**SUSQUEHANNA STEAM ELECTRIC STATION  
APPLICATION FOR RENEWED OPERATING LICENSES  
NUMBERS NPF-14 AND NPF-22 REQUESTS FOR ADDITIONAL  
INFORMATION - LICENSE RENEWAL APPLICATION (LRA)  
SECTION 2.3.3.13  
PLA-6241**

**Enclosure to PLA-6241  
PPL Follow-up Responses to NRC's  
Request for Additional Information (RAI)**

**Attachment to PLA-6241**  
**Boundary Drawing LR-M-122 Sheet 4**  
**(Revised)**

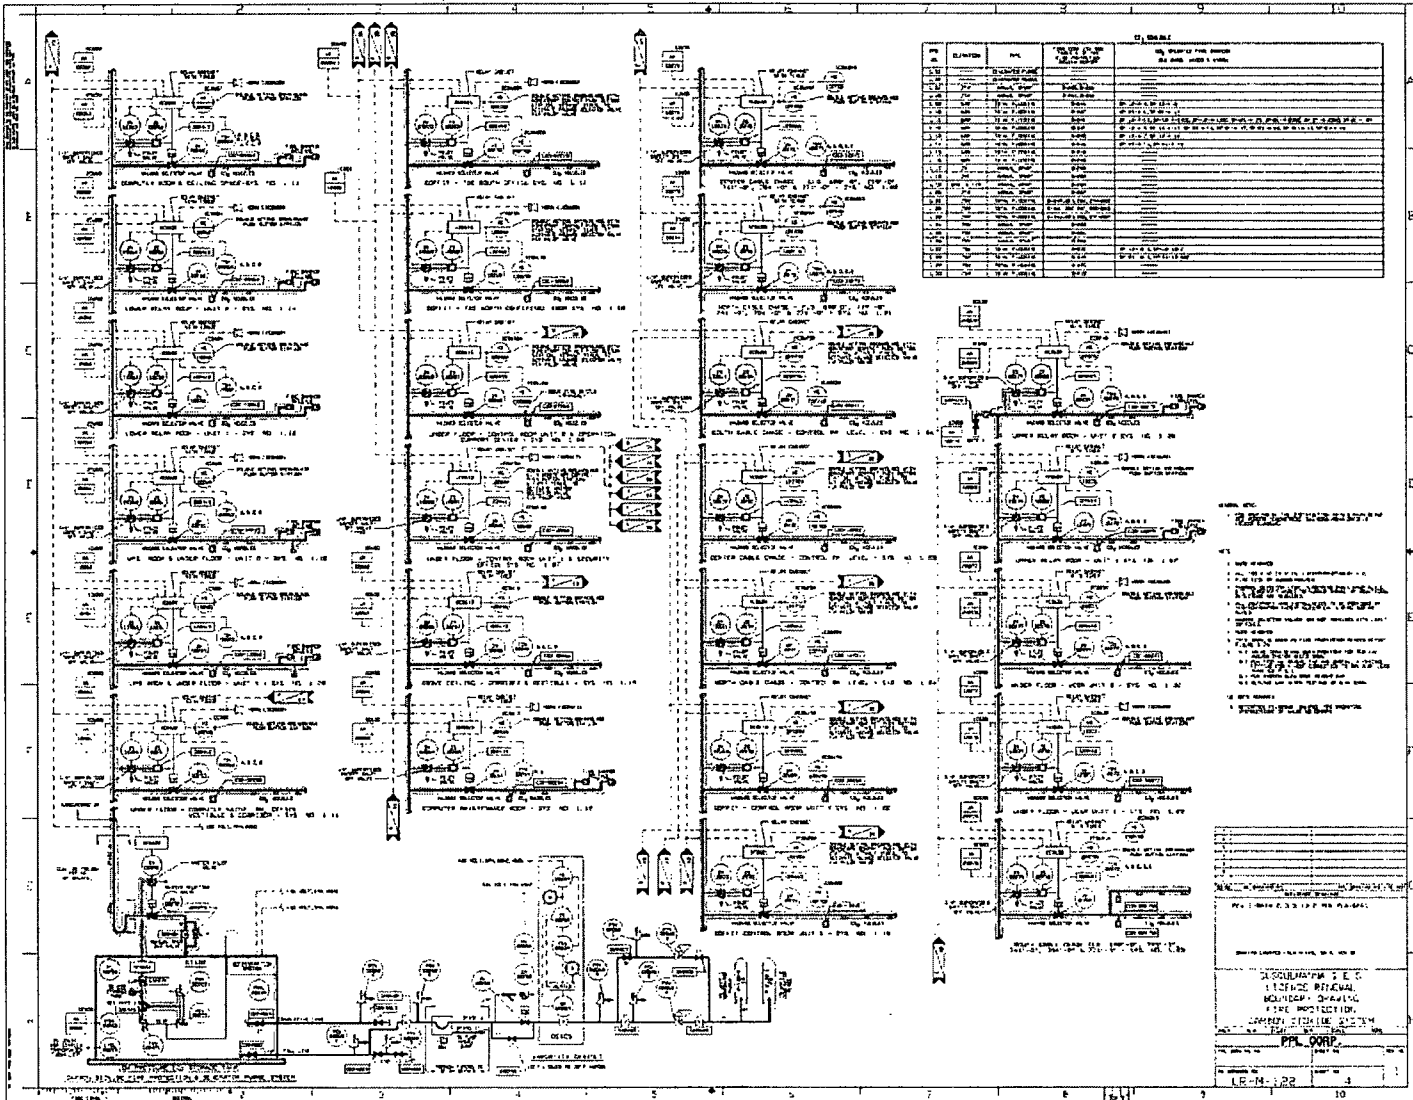
LRA Section 2.3.3.13 discusses requirements for the fire water supply system but does not mention trash racks and traveling screens for the fire pump suction water supply. Trash racks and traveling screens are located upstream of the fire pump suctions to remove any major debris from the fresh or raw water. Trash racks and traveling screens

are necessary to remove debris from and prevent clogging of the fire protection water supply system. Trash racks and traveling screens are typically considered to be passive, long-lived components. Both trash racks and traveling screens are located in a fresh or raw water/air environment and are typically constructed of Carbon steel. Carbon steel in a fresh or raw water environment or water/air environment is subject to loss of material, pitting, crevice formation, and microbiologically influenced corrosion, and fouling. Explain the apparent exclusion of the trash racks and traveling screens that are located upstream of the fire pump suction from the scope of license renewal in accordance with 10 CFR 54.4(a) and subject to an AMR in accordance with 10 CFR 54.21(a)(1).

As described in LRA Section 2.3.3.13, System Description, Water Supplies, the primary source of fire protection water is the Clarified Water Storage Tank, addressed in LRA Section 2.3.3.21, and the second and third sources are the basins of hyperbolic natural draft cooling towers for Units 1 and 2, addressed in LRA Section 2.3.3.6. Accordingly, the fire pumps at SSES are horizontal, centrifugal type pumps as described in FPRR Section 4.1, rather than vertical wet pit pumps, and do not take suction from an open bay. Since the pumps do not take suction from a natural source or bay, trash racks and traveling screens are neither required nor installed at SSES.

Boundary drawings LR-M-115, sheet 1 and LR-M-2115, sheet 1, which are identified in LRA Section 2.3.3.6, show the outlet screens for the cooling tower basin as in the scope of license renewal (highlighted green). As described in LRA Section 2.4.9.6, LRA Table 2.4-9, and LRA Table 3.5.2-9, the Cooling Tower Basin Outlet Screens are in license renewal scope and are subject to AMR as structural commodities. They are constructed of stainless steel and are fixed screens.
